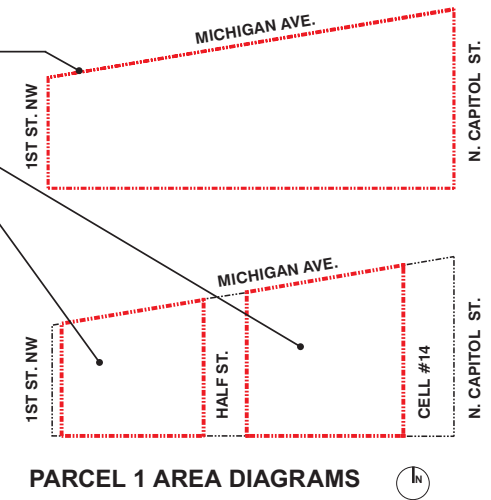
- A. The 9th floor was removed from the west wing of the west structure, bringing the building height from 130' to 115'.
- B. Due to the adjustment of the building height from 130' to 115', the rear yard requirement was adjusted.
- C. In order to improve the siteline from the AFRH, the west edge of the building was shifted 15' east, adjusting Lot Occupancy

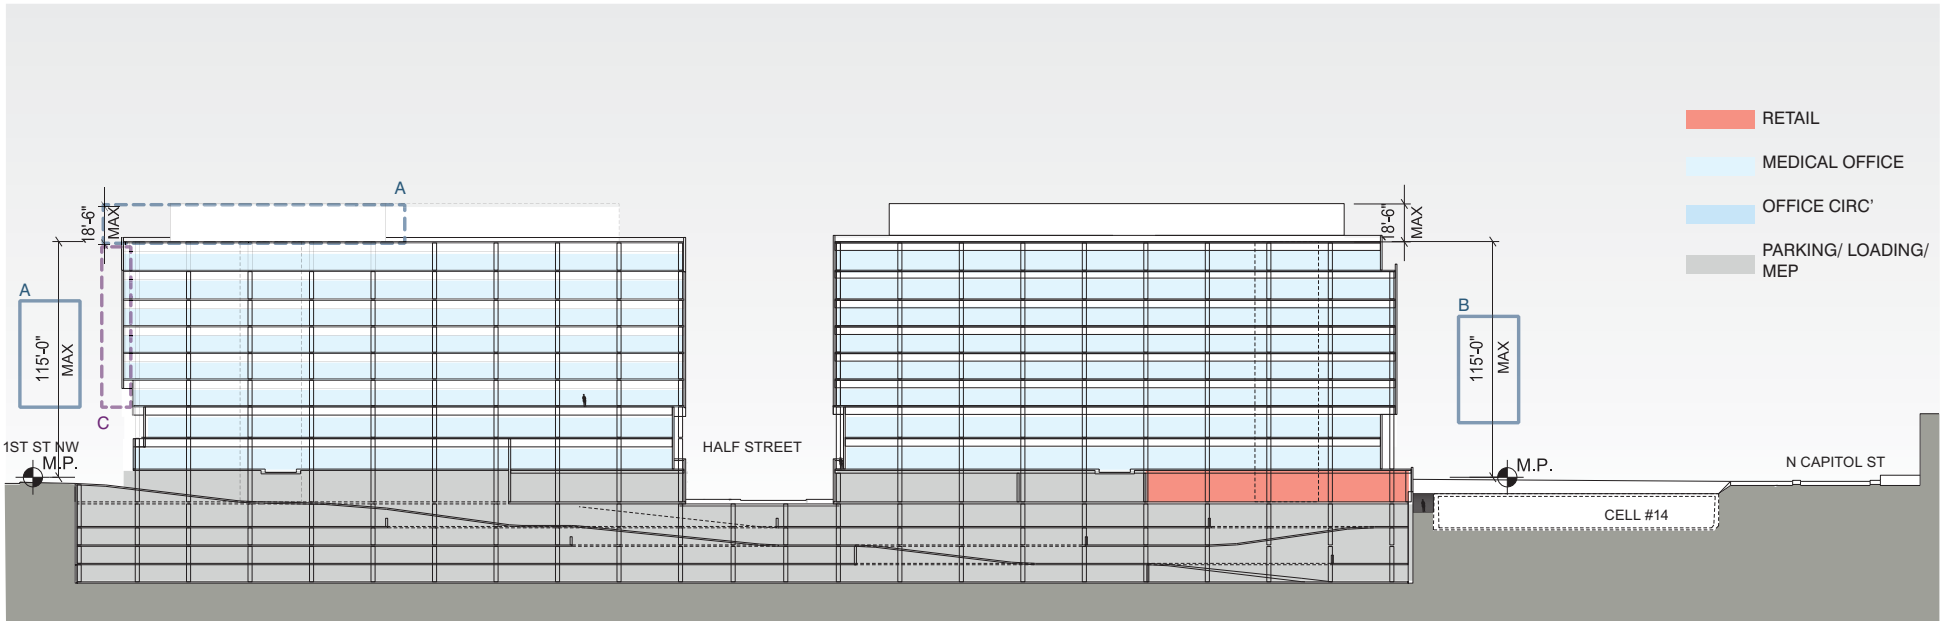
A. The 9th floor was removed from the west wing of the west structure, bringing the building height from 130' to 115'.

B. The building height was adjusted from 115'4" down to 115'.

C. Due to the adjustment in item B, the building height for the east wing of the east structure was adjusted from 102'2" to 101'.

D. Due to the adjustment of the building height from 130' to 115', the rear yard requirement was adjusted.

E. In order to improve the siteline from the AFRH, the west edge of the building was shifted 15' east

SECTION 1

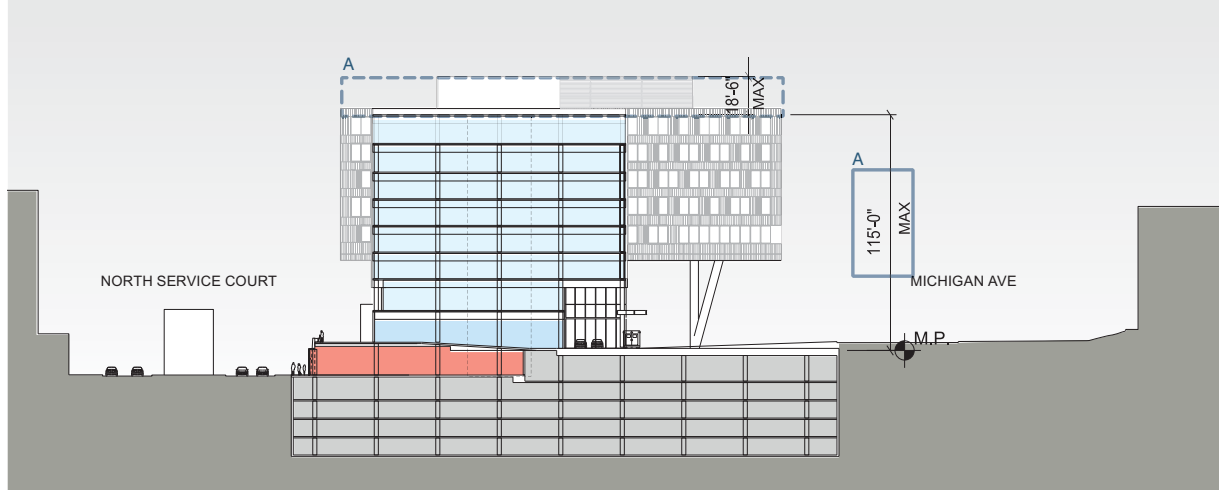
A. The 9th floor was removed from the west wing of the west structure, bringing the building height from 130' to 115'.

B. The height of the west wing of the building, which previously reached a maximum height of 130 feet as permitted under the 1910 Height Act, was measured to the top of the parapet in accordance with that Act. ("No parapet wall shall extend above the limit of height, except on nonfireproof dwellings...." D.C. Code 6-601.07). With the elimination of the 9th floor on the west wing, the 1910 Height Act is no longer implicated and the building is now measured in accordance with the zoning definition of building height. See 11 DCMR 199.1 ("[I]n those district in which the height of building is permitted to be ninety feet (90 ft.) or greater, the height of the buildings shall be measured to the highest point of the roof excluding parapets not exceeding four feet (4 ft.) in height.").

C. In order to improve the siteline from the AFRH, the west edge of the building was shifted 15' east

5. NORTH ELEVATION

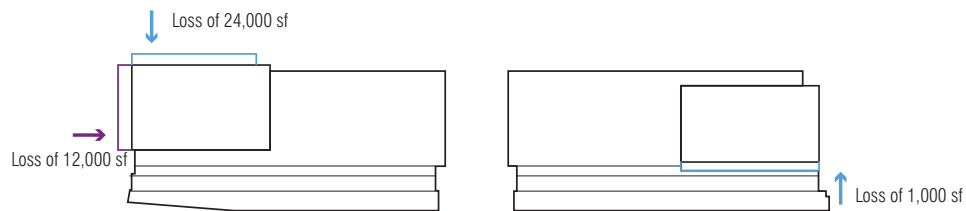
- A. The 9th floor was removed from the west wing of the west structure, bringing the building height from 130' to 115'.
- B. In order to maintain the design intent, the east wing of the east structure was adjusted in order to match the proportions of the west wing of the west structure.
- C. In order to improve the siteline from the AFRH, the west edge of the building was shifted 15' east
